RE: Prairie Point Site Plan No 1 (Kings Point North) Fourth Submission Review Response to Comments

On behalf of Clayton Properties Group LLC, EMK Consultants Inc., Fox Tuttle Transportation Group, and Terracina Design, we have reviewed the comments from the 4th Submission Review for the Prairie Point Site Plan No1 (Kings Point North) and Plat. The following is a response to comments:

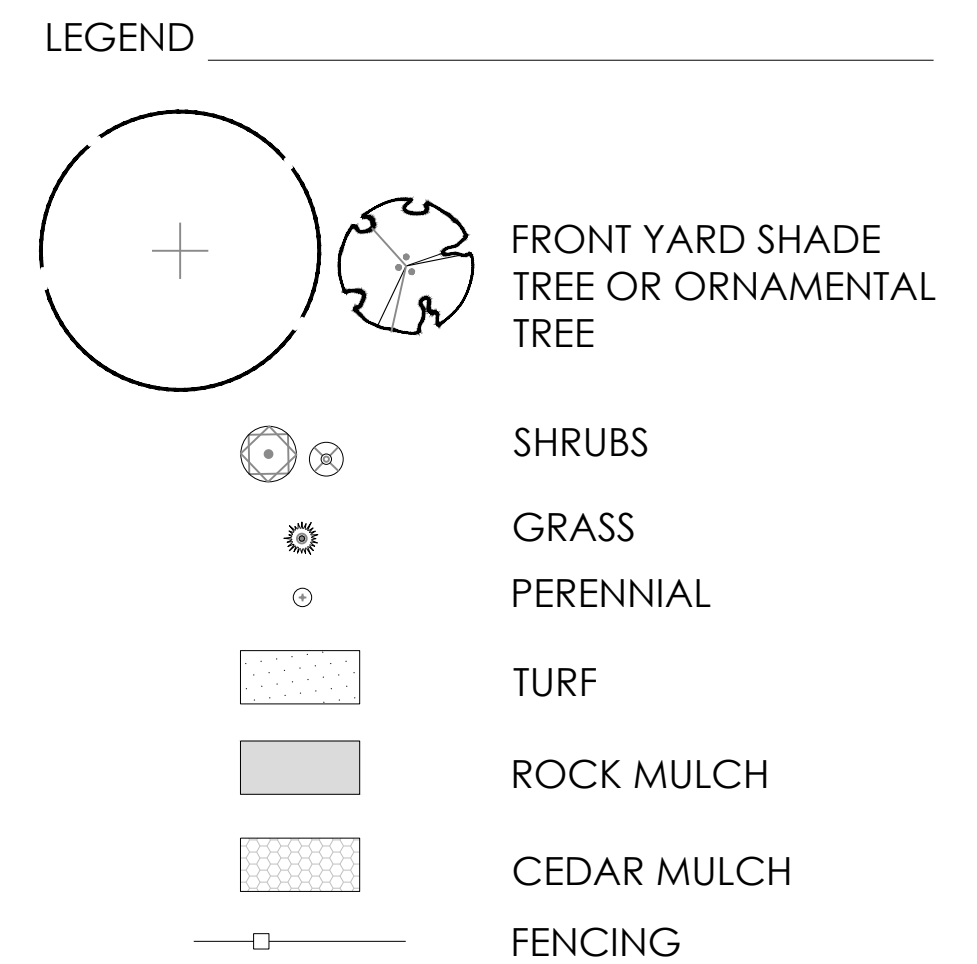
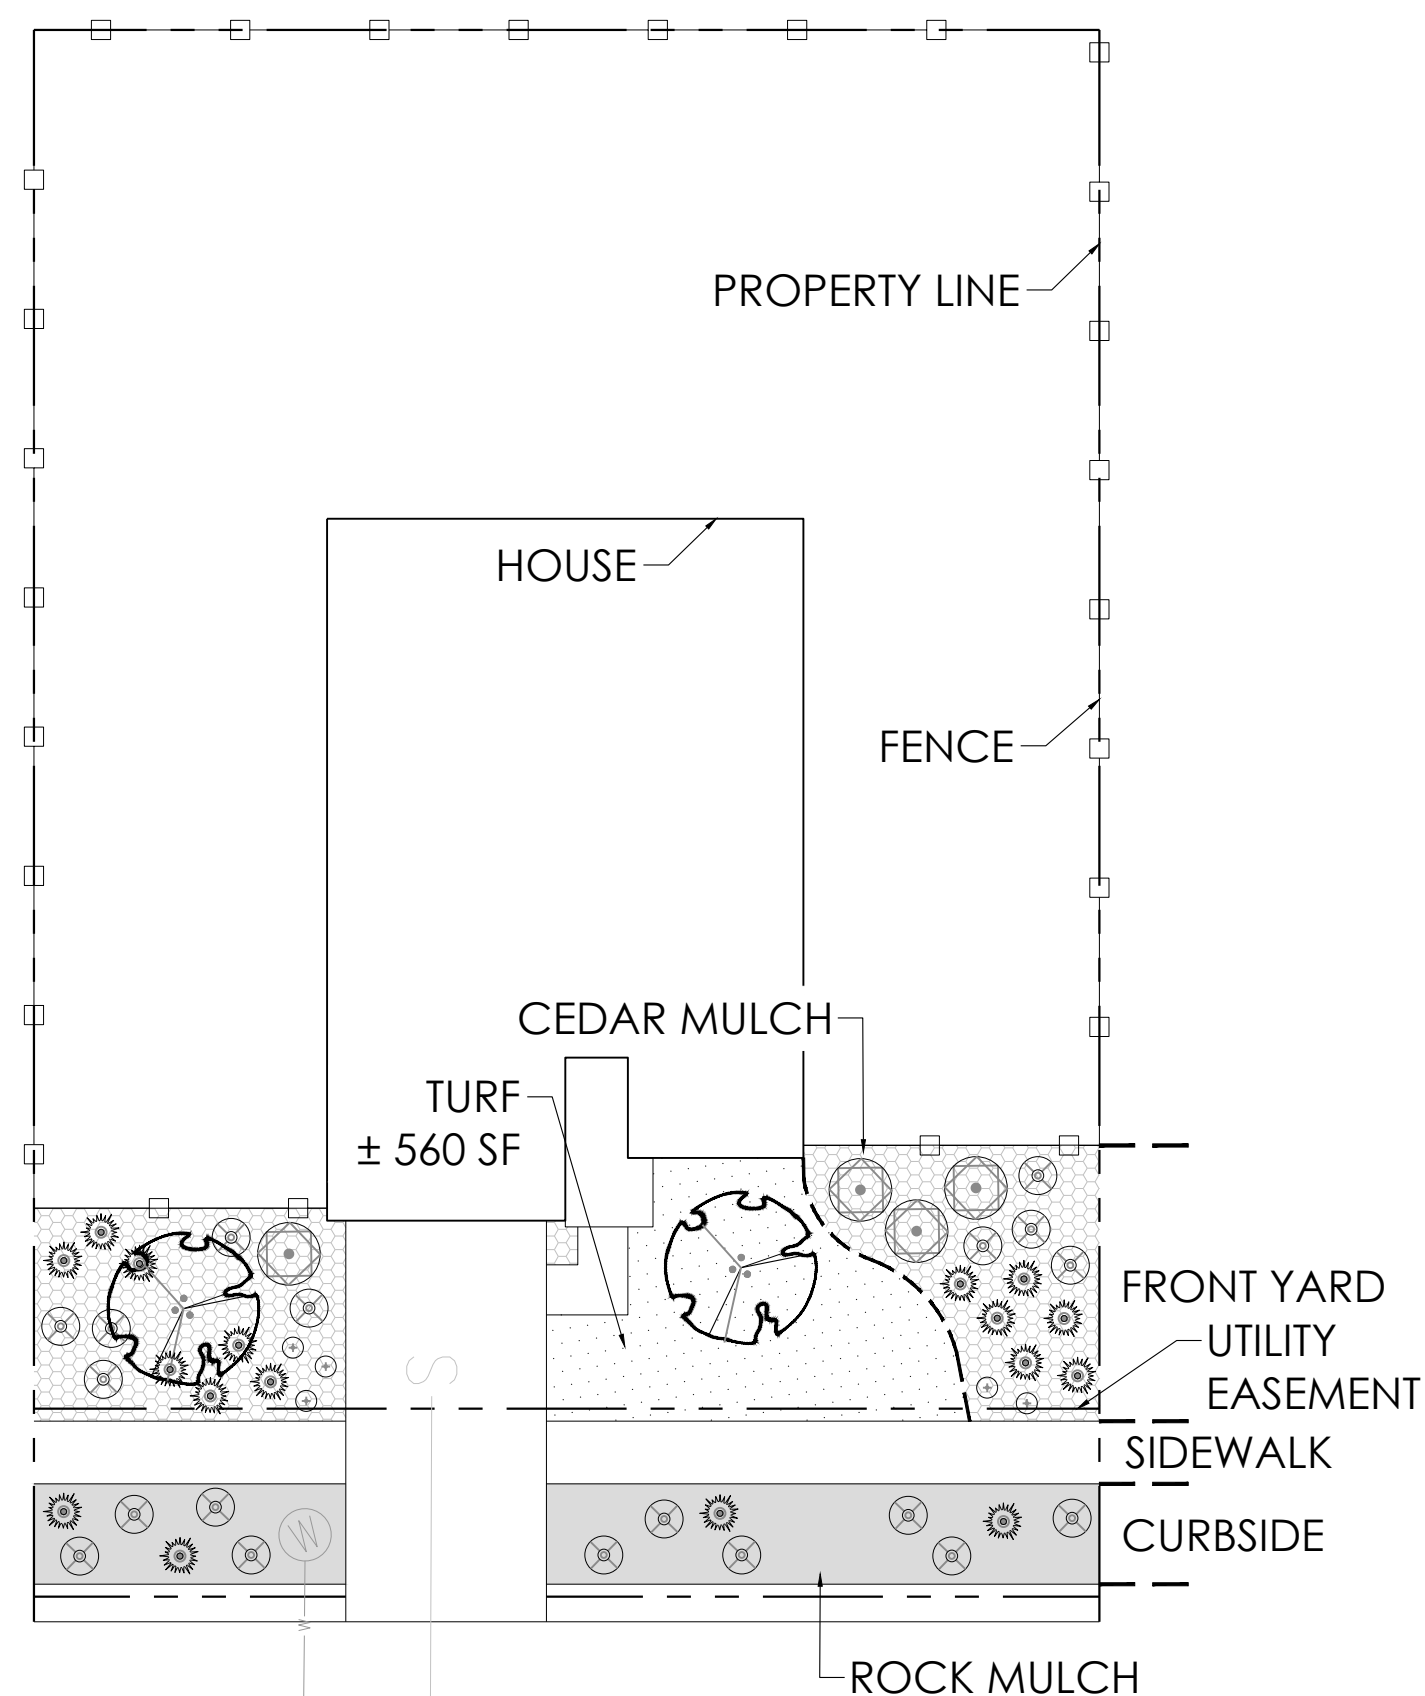
For all typicals: The should be drawn to a scale, and also include the building front setbacks on the plans. Also, show the utility easements correctly as the plans show some with 6' easements and others with 10' easements.

RESPONSE: THE TYPICALS ARE NOW SET TO A SCALE. THE BUILDING FRONT SETBACKS ARE LABELED AND THE UTILITY EASEMENTS ARE SHOWN PER PLAN.

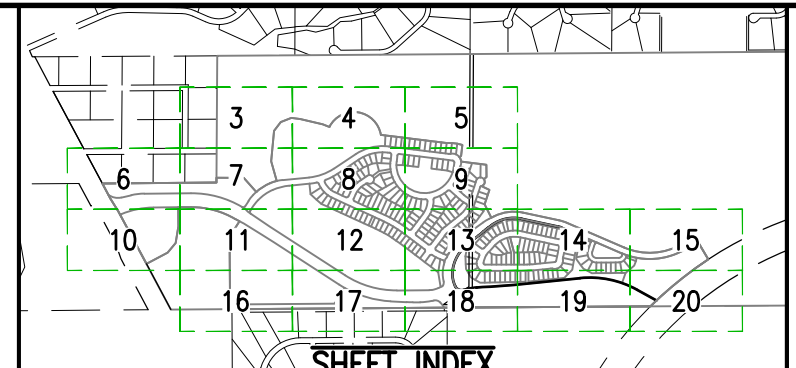
Label Bearings & Distances of
easements within the platted area and tie
to subdivision exterior (Typical)

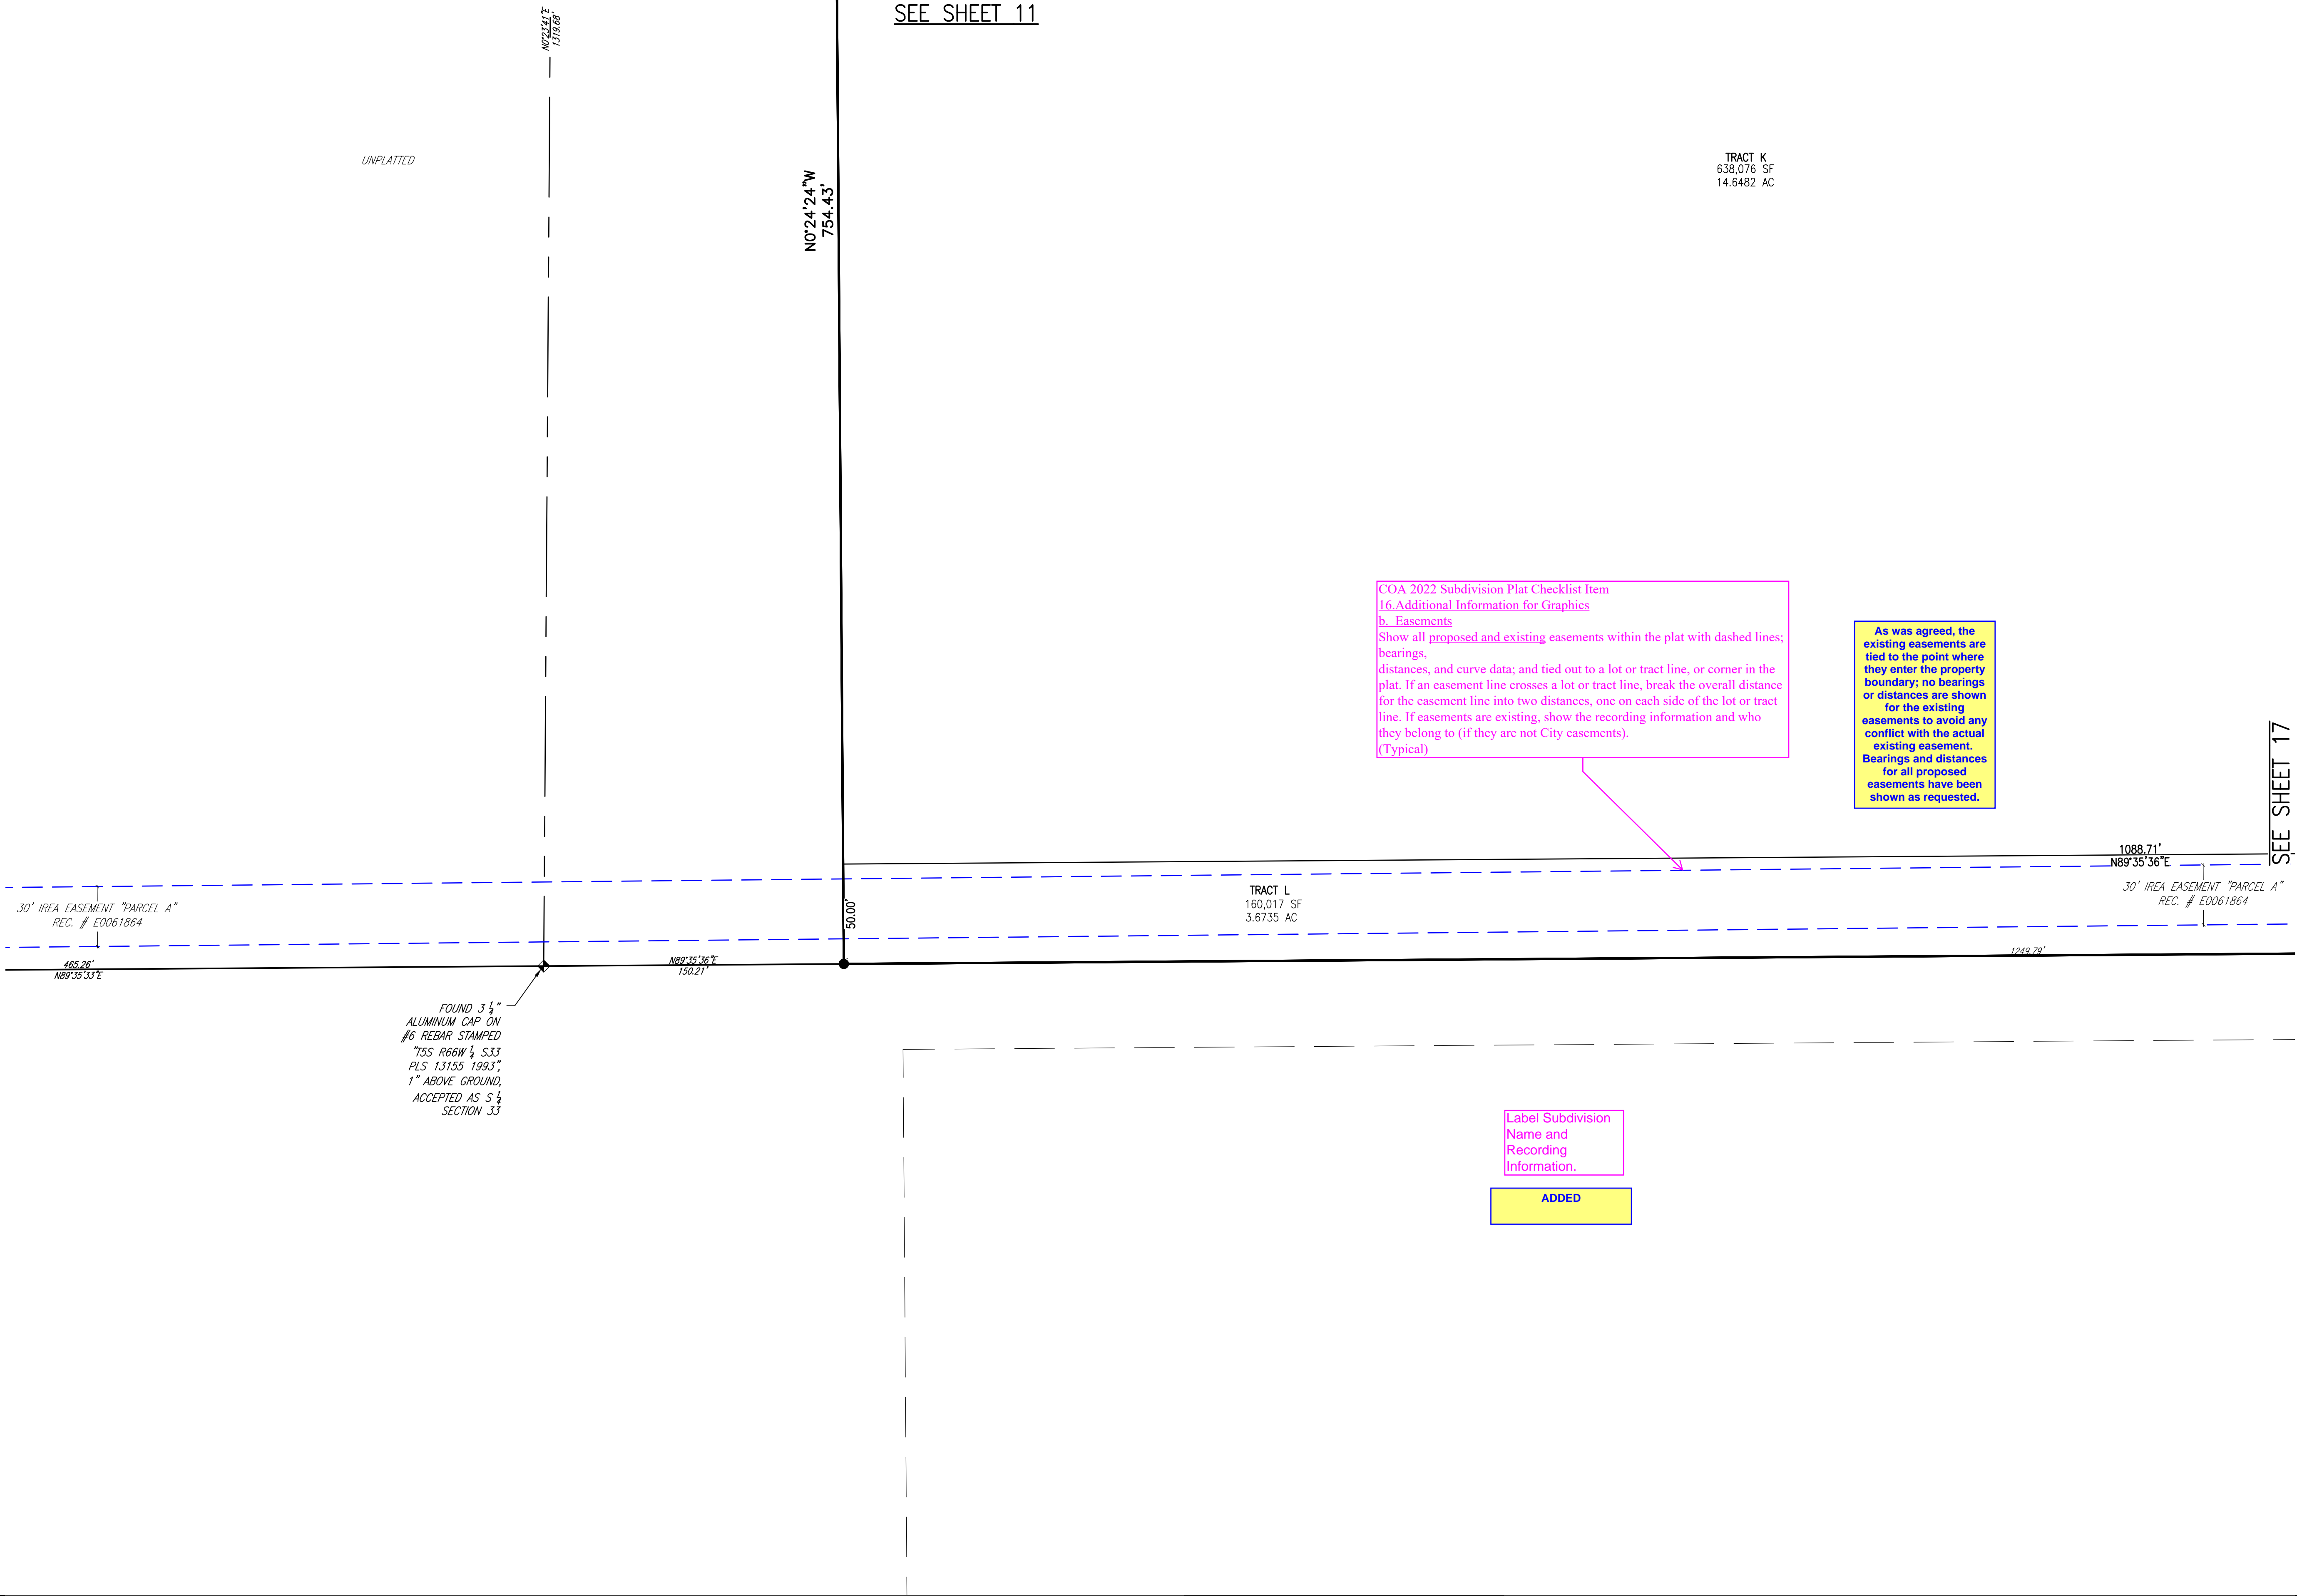
COA 2022 Subdivision Plat Checklist Item
16. Additional Information for Graphics
b. Easements
Show all proposed and existing easements within the plat with dashed lines; bearings,
distances, and curve data; and tied out to a lot or tract line, or corner in the plat. If an easement line crosses a lot
or tract line, break the overall distance for the easement line into two distances, one on each side of the lot or
tract line. If easements are existing, show the recording information and who they belong to (if they are not City
easements).
(Typical)

As was agreed, the
existing easements are
tied to the point where
they enter the property
boundary; no bearings
or distances are shown
for the existing
easements to avoid any
conflict with the actual
existing easement.
Bearings and distances
for all proposed
easements have been
shown as requested.
